Planning Applications Sub-Committee

SUPPLEMENTARY PACK 4

Comments from Statutory Consultees

4. **SITE COMPRISING LIVERPOOL STREET STATION, 50 LIVERPOOL STREET, SUN STREET PASSAGE, 40 LIVERPOOL STREET (IN PART), HOPE SQUARE AND BISHOPSGATE PLAZA LONDON, EC2M 7PY (25/00494/FULEIA AND ASSOCIATED LISTED BUILDING CONSENTS 25/00474/LBC, 25/00479/LBC, 25/00475/LBC, 25/00476LBC AND 25/00477/LBC)**

Figure 1: NR Platform and concourse LEGION modelling undertaken based on the existing baseline 'Do Minimum', against the forecasted 2041+35% demand profile²

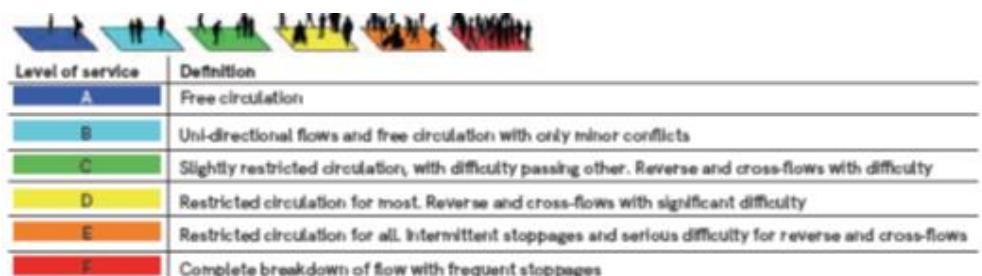
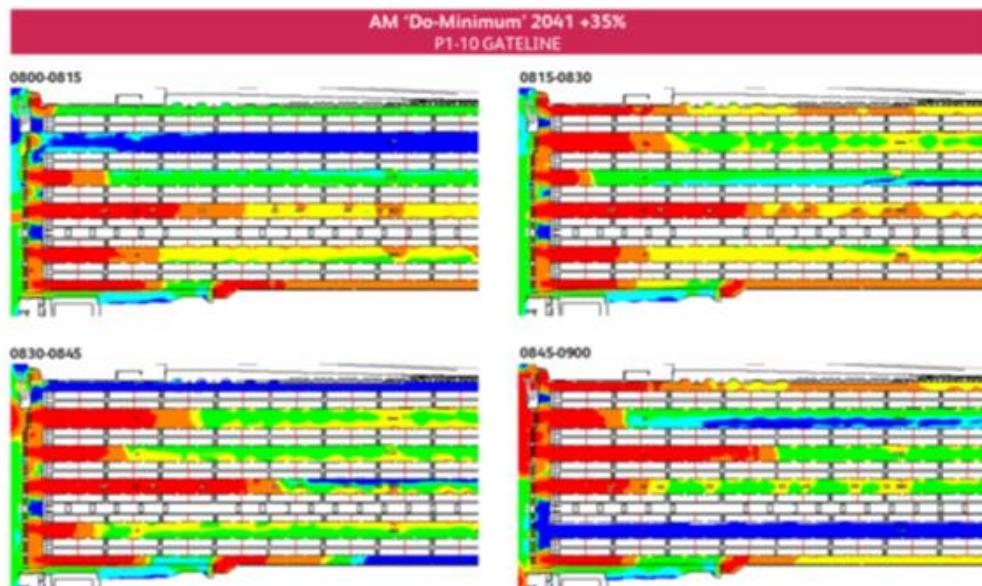
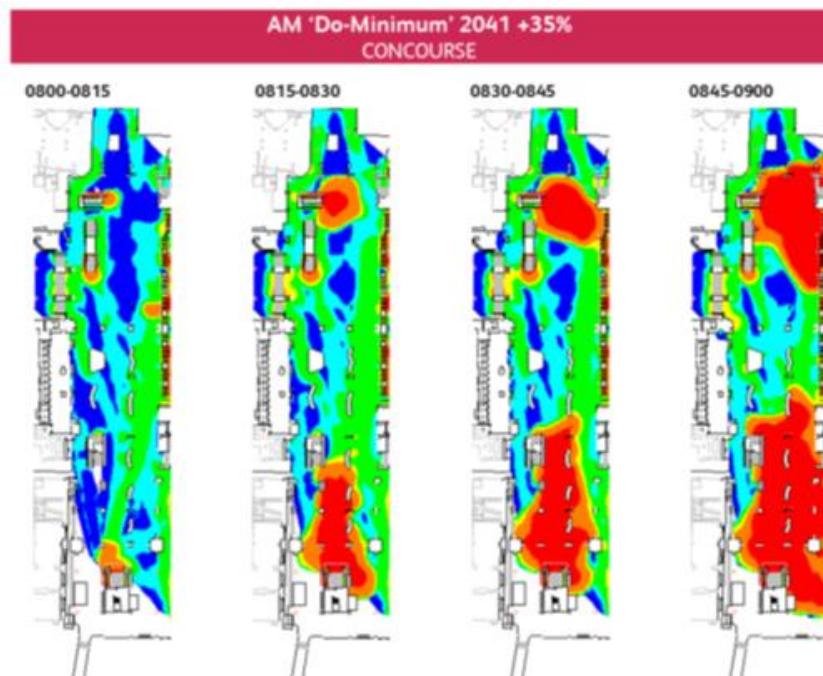
The design and layout changes proposed to improve the station's current and future capacity have therefore been identified and will be further verified through additional modelling. In the 'do something' scenario, queuing in the lower concourse and NR platforms would greatly reduce (Figure 2), and future capacity challenges in the station would be substantially addressed, which is supported.

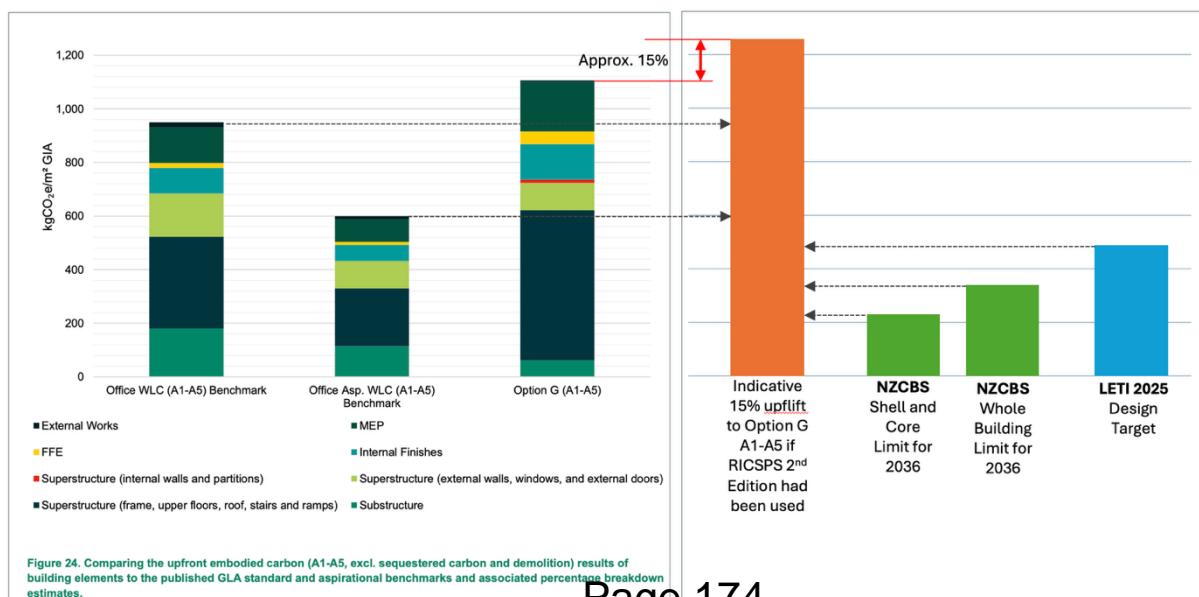
- The diagram below shows the Submission Diagram comparing the Option G, adopted scheme Upfront Carbon A1-A5 carbon assessment against the Standard GLA Office Benchmark, and also the Aspirational Benchmark.
- The **Orange** column shows 'Option G' with an indicative (and possibly conservative) corrected 15% uplift reflecting what the assessment is likely to look like had RICSPS 2nd Edition been correctly used for the assessment.
- The two **Green** columns show respectively the NZCBS 'shell and core limit' and the 'whole building limit' for offices completed in 2036. (It is the shell and core limit that will apply).
- The **Blue** column shows the LETI 2025 Design Target.
- The **black arrows** show the shortfall between the orange column, and the respective benchmarks, limits and targets.

- Conclusion:** This combined diagram shows the likely uplift from using RICSPS 2nd Edition rather than the now redundant 1st Edition. It shows how much this building will miss the GLA 'Office WLC (A1-A5) Benchmark' (by approx. 33%), and the 'Office Asp. WLC (A1-A5) Benchmark' (over double).

- Conclusion:** This combined diagram also shows that the orange, corrected, Option G column is nowhere near meeting industry best practice limits/targets illustrated by the green and blue columns. It is important to note that the NZCBS (Green) limits are designed to meet the government's required trajectory to net zero.

5.2. The 'Carbon Optioneering Report P02' shows that initially 7 Options A-G were considered. See diagram below from 'Carbon Optioneering Part 1 p6:

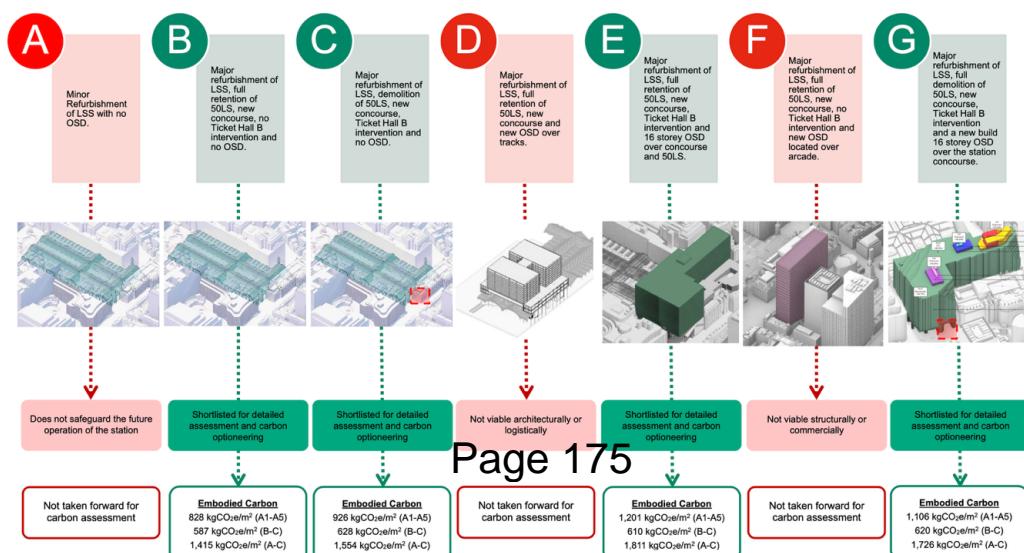
5.1. Strategic options were considered as described in 5.2 below. However, only a single, high carbon, structural option was considered (see 5.3, last paragraph below) and only a single, short life, cladding option was considered (see 5.4 and 5.5). Therefore the 'Optioneering' process did not look at options for these significant elements of construction.

This rejects Options A, D, F in favour of a more detailed examination of Options B, C, E, G. Based on the applicant's assumptions on viability, and the need to pay for the station improvements, this in effect leaves only options E and G in contention. Options B and C appear to be retained really only to give a degree of validity to the optioneering as the clear requirement was to build a new office building in the location shown. This is a very restricted range of options, excluding other structural possibilities, see 5.3 below.

Figures 18 and 19. 3D model showing proposed transfer and stability structure over station concourse and OSD cores.

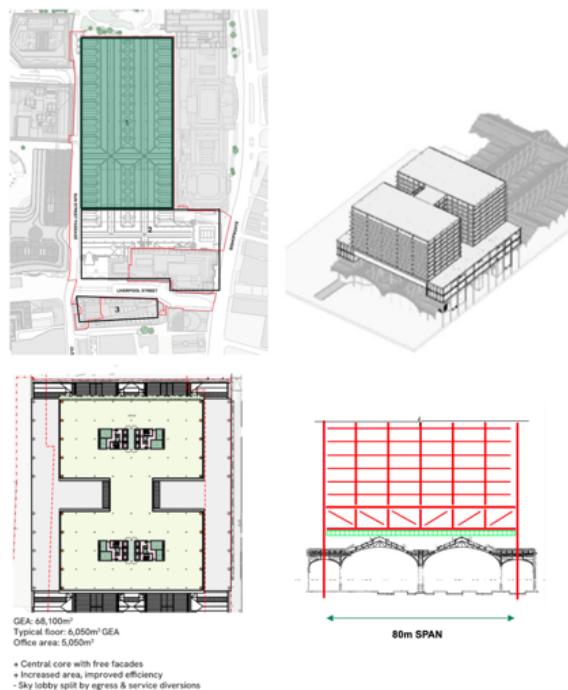
- In the Submission Document 'GLA Stage 2-3 Whole Life Carbon Assessment' para 1.6.3. there is the statement "*The upfront (A1-A5) carbon emissions of the transfer structure alone accounts for around 25% of 1,110 kgCO2e/m2. Without the transfer structure, the OSD may perform more favourably with the GLA's A1-A5 benchmark*". This observation raises the question as to why a more imaginative solution wasn't examined that does not require a large transfer structure, which would have removed the need for this type of high carbon design approach, and potentially help reduce construction costs. The 'Carbon Optioneering Report P02' Option G p13 Figures 18 and 19, show the massive high carbon transfer structure that is required below.

- The structural solutions for both Options and E and G are essentially the same and involve a significant transfer structure over the station concourse to be achieved. It has already been stated in the submission that this design approach was exceptionally high carbon adding some '25%' to the assessment figures (see

Rejected Option D, “Carbon Optioneering Part 1 P02”, p27, showing high carbon transfer structure.

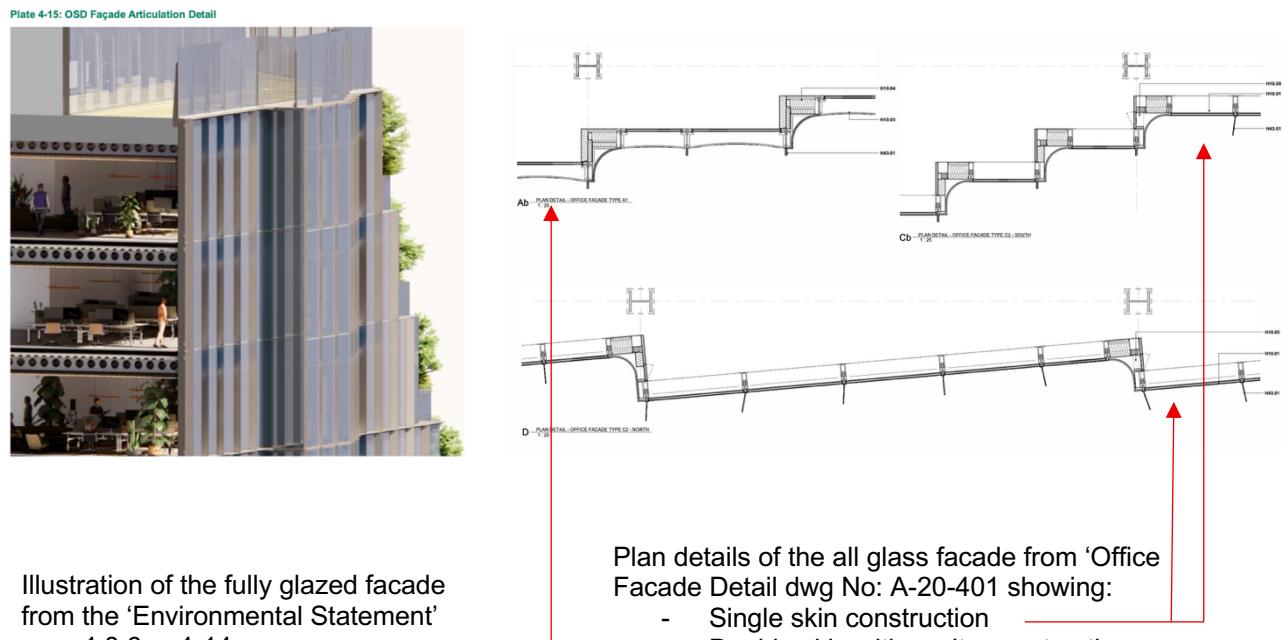
above para). The obvious solution to this problem is already evidenced on site with Exchange House which spans the tracks of Liverpool Street Station with a parabolic (tension) structure. This is potentially a much lower carbon approach which would very likely have avoided the ‘25%’ additional carbon cost necessitated by the transfer structure. This would have brought the rejected Option D, described in the above diagram (5.2 above) as ‘*Not viable architecturally or logically*’ back into contention, as Exchange House has historically managed to solve both the architectural and logistical issues from building over the railway tracks at this station.

- Cross Laminated Timber (CLT) as a low carbon structural solution: CLT structural floors would seem to be a potential solution for this project solving two major issues, structural mass and carbon emissions. A basic structural problem with the submission is the weight bearing down on the transfer structure which would have been mitigated using CLT. In addition, CLT structural slabs would have not only have had a reduced carbon emissions impact from construction but could also have had a significant sequestration benefit. The reason given for this omission is ‘*Insurance*’ concerns. However, Landsec’s Timber Square Building in

Figure 12: Plan view of 7th floor showing façade types

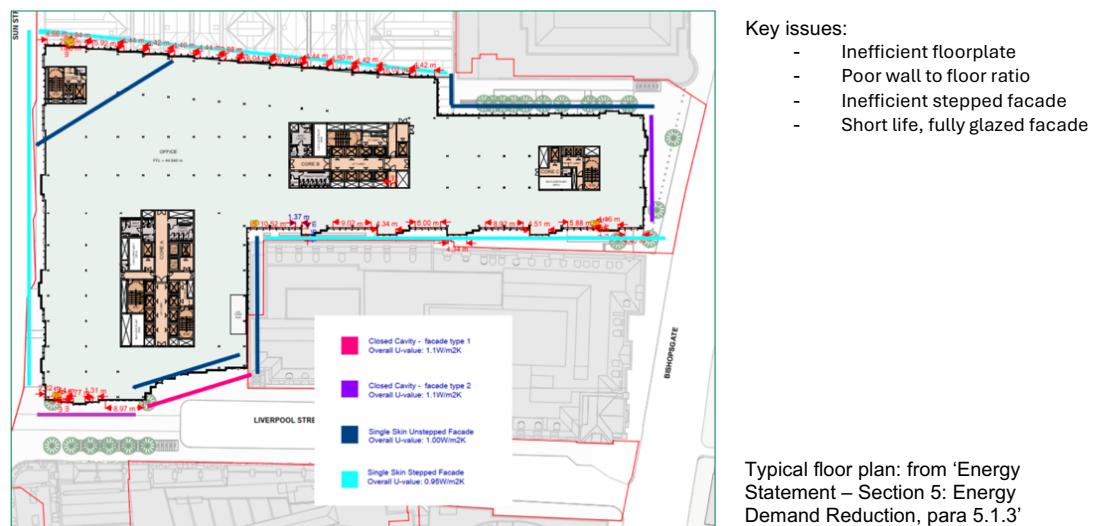
- The typical floor plan shown below (Submission 'Energy Statement – Section 5: Energy Demand Reduction, para 5.1.3') shows that the fully glazed facade is also inefficient in terms of wall to floor ratio. Apart from the inherently sub-optimum shape, the continual stepping of the facade adds to the overall surface area of the building, increasing material, i.e. embodied carbon costs, and is also consequently unhelpful to heat loss/gain. A more efficiently designed facade from both material and shape perspectives would contribute to greater facade longevity and improved operational performance. This floor plan cannot therefore be said to be 'exemplary' (see para 8.4 below, ref City Plan 2040 para 1.4)

5.6. **Comment:** This facade solution is not "An optimised façade responding to the external environment, with external shading" (LSSt Sustainability Statement March 2025 para 1.3.2.2) as claimed, and is as explained above, not a sustainable design approach in both embodied carbon and energy use terms. This is particularly concerning in the face of a climate crisis and the government's legally binding target of achieving Net Zero by 2050, and improved energy efficiency. The City's stated objective is to achieve Net Zero by 2040. The first facade replacement would be in about 2066, i.e. 16 years after 2050, and 26 years after 2040. It is very likely that given the current direction of continually tightening environmental legislation, and parallel ESG concerns by occupiers, that double glazed, all glass facades will no longer be possible for regulatory or commercial reasons. Will the structural solution be able to support a different, possibly heavier, long life facade solution when the building is vacated and refurbished in 2066, 2096 etc? **This building is therefore likely to be obsolete on completion.**

Demolition Site Plan – Extract from Dwg: A-04-200

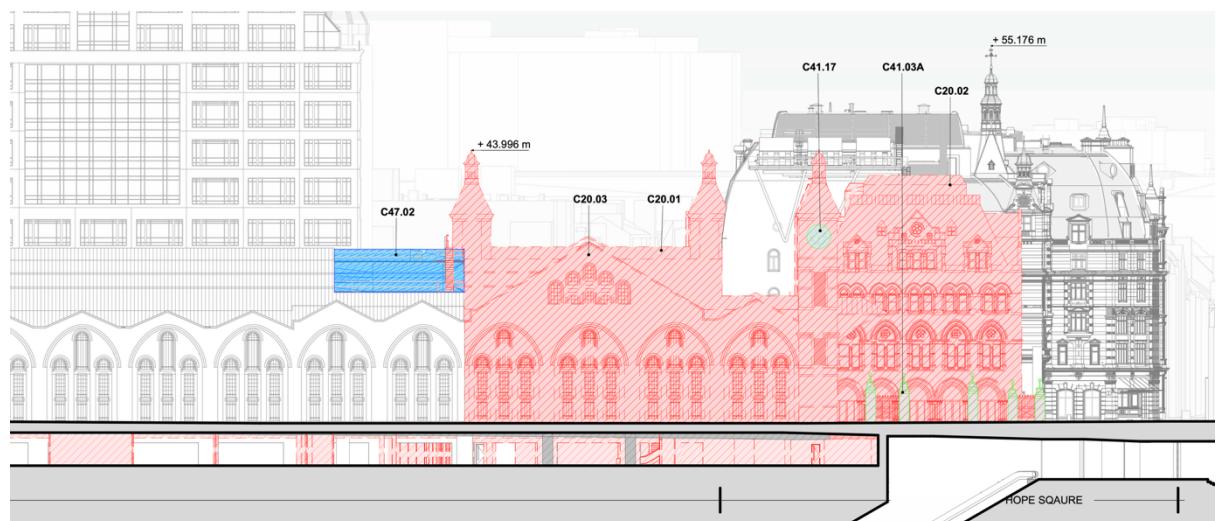
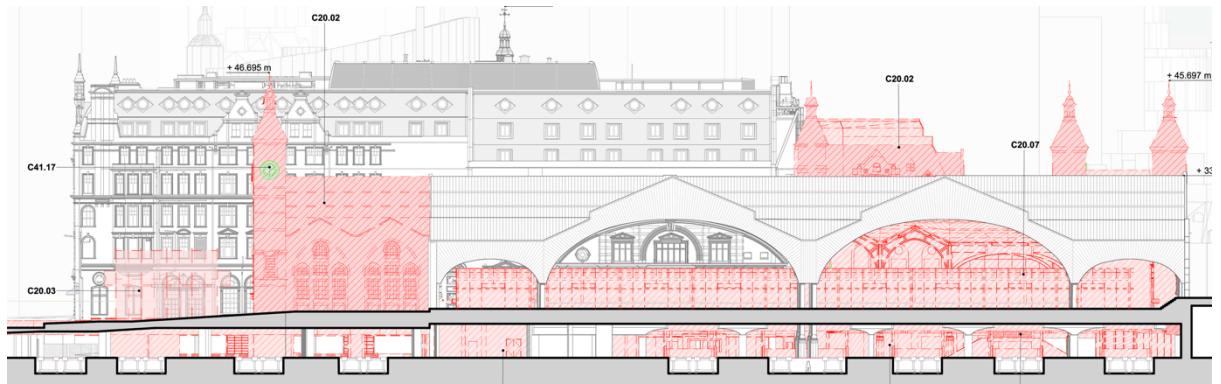
7.2. The proposed demolitions are extensive and predominantly involves fabric that has not reached the end of its useful life. Fabric and buildings subject to demolition are therefore entirely capable of retention and reuse. The concerns with respect to demolition are specifically associated with the buildings that face onto Liverpool Street and Bishopsgate.

Figure 24. Comparing the upfront embodied carbon (A1-A5, excl. sequestered carbon and demolition) results of building elements to the published GLA standard and aspirational benchmarks and associated percentage breakdown estimates.

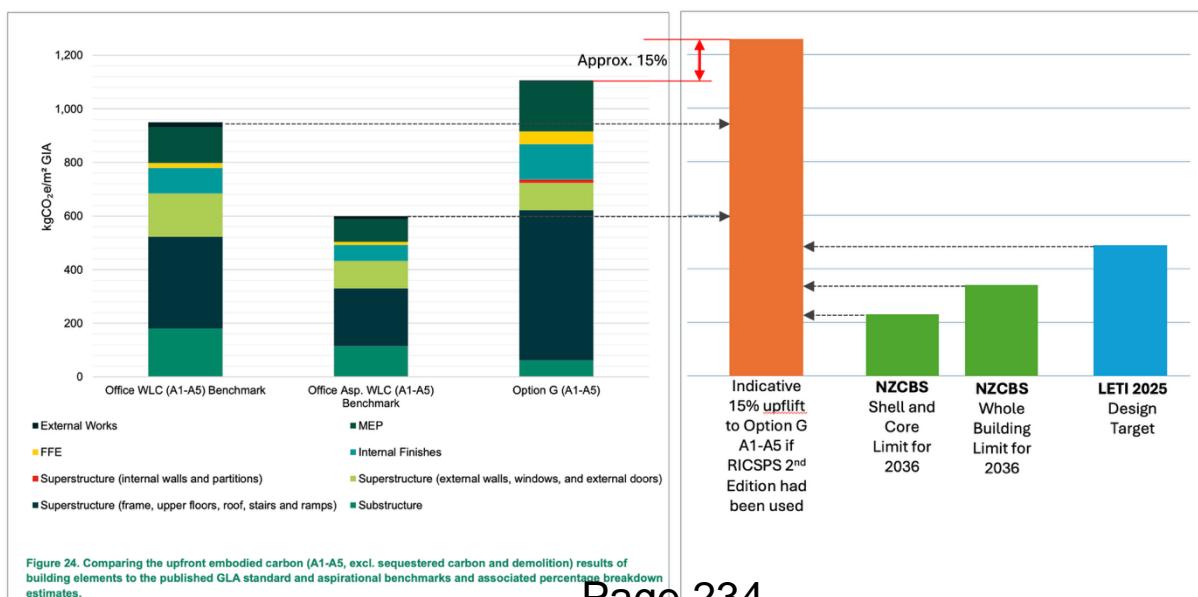
- The diagram below shows the Submission Diagram comparing the Option G, adopted scheme Upfront Carbon A1-A5 carbon assessment against the Standard GLA Office Benchmark, and also the Aspirational Benchmark.
- The **Orange** column shows 'Option G' with an indicative (and possibly conservative) corrected 15% uplift reflecting what the assessment is likely to look like had RICSPS 2nd Edition been correctly used for the assessment.
- The two **Green** columns show respectively the NZCBS 'shell and core limit' and the 'whole building limit' for offices completed in 2036. (It is the shell and core limit that will apply).
- The **Blue** column shows the LETI 2025 Design Target.
- The **black arrows** show the shortfall between the orange column, and the respective benchmarks, limits and targets.

- Conclusion:** This combined diagram shows the likely uplift from using RICSPS 2nd Edition rather than the now redundant 1st Edition. It shows how much this building will miss the GLA 'Office WLC (A1-A5) Benchmark' (by approx. 33%), and the 'Office Asp. WLC (A1-A5) Benchmark' (over double).

Figures 18 and 19. 3D model showing proposed transfer and stability structure over station concourse and OSD cores.

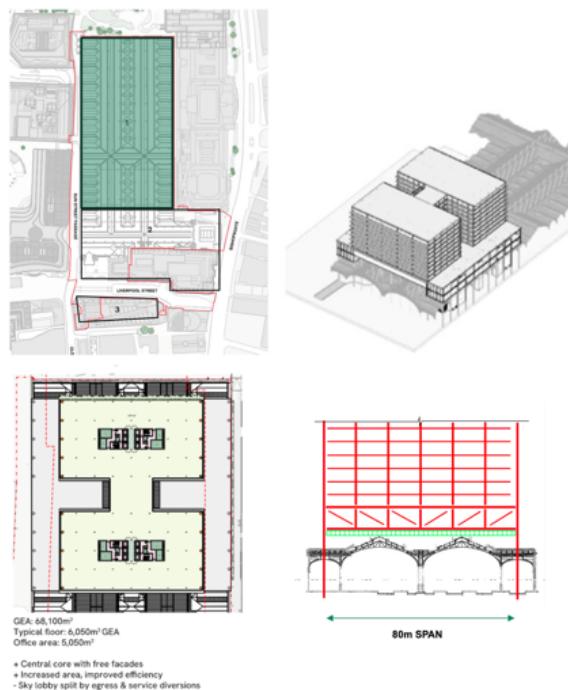
- In the Submission Document 'GLA Stage 2-3 Whole Life Carbon Assessment' para 1.6.3. there is the statement "*The upfront (A1-A5) carbon emissions of the transfer structure alone accounts for around 25% of 1,110 kgCO2e/m2. Without the transfer structure, the OSD may perform more favourably with the GLA's A1-A5 benchmark*". This observation raises the question as to why a more imaginative solution wasn't examined that does not require a large transfer structure, which would have removed the need for this type of high carbon design approach, and potentially help reduce construction costs. The 'Carbon Optioneering Report P02' Option G p13 Figures 18 and 19, show the massive high carbon transfer structure that is required below.

- The structural solutions for both Options and E and G are essentially the same and involve a significant transfer structure over the station concourse to be achieved. It has already been stated in the submission that this design approach was exceptionally high carbon adding some '25%' to the assessment figures (see

Rejected Option D, “Carbon Optioneering Part 1 P02”, p27, showing high carbon transfer structure.

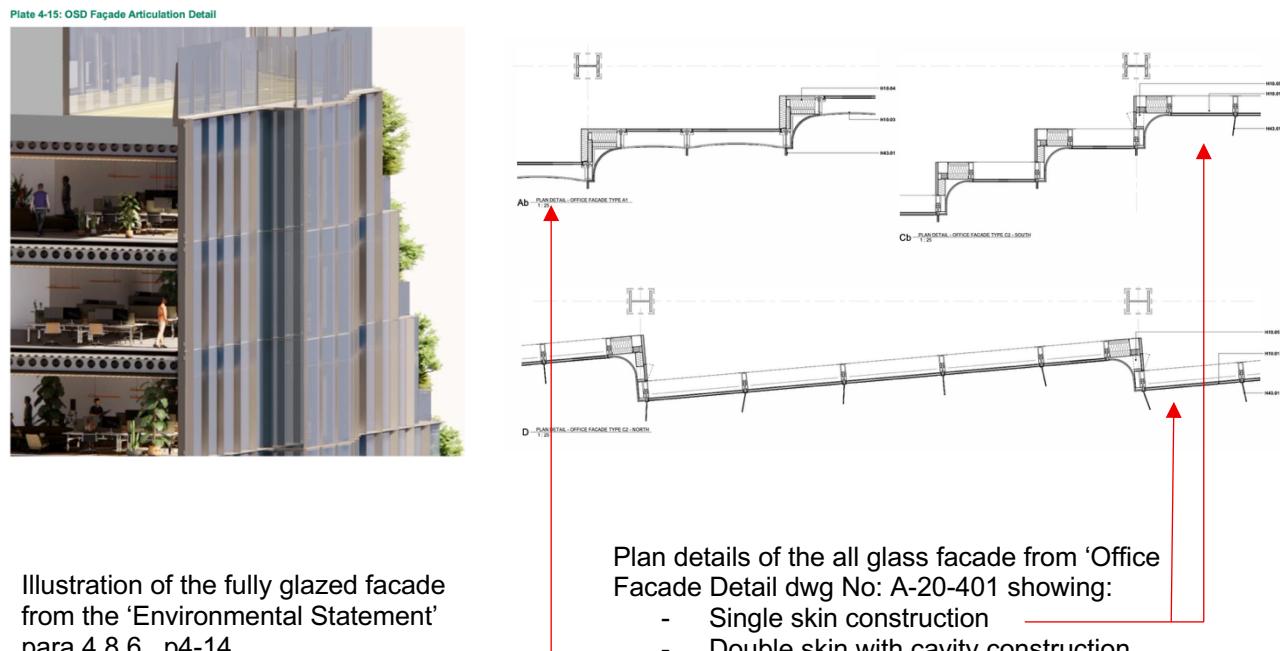
above para). The obvious solution to this problem is already evidenced on site with Exchange House which spans the tracks of Liverpool Street Station with a parabolic (tension) structure. This is potentially a much lower carbon approach which would very likely have avoided the ‘25%’ additional carbon cost necessitated by the transfer structure. This would have brought the rejected Option D, described in the above diagram (5.2 above) as ‘*Not viable architecturally or logically*’ back into contention, as Exchange House has historically managed to solve both the architectural and logistical issues from building over the railway tracks at this station.

- Cross Laminated Timber (CLT) as a low carbon structural solution: CLT structural floors would seem to be a potential solution for this project solving two major issues, structural mass and carbon emissions. A basic structural problem with the submission is the weight bearing down on the transfer structure which would have been mitigated using CLT. In addition, CLT structural slabs would have not only have had a reduced carbon emissions impact from construction but could also have had a significant sequestration benefit. The reason given for this omission is ‘*Insurance*’ concerns. However, Landsec’s Timber Square Building in
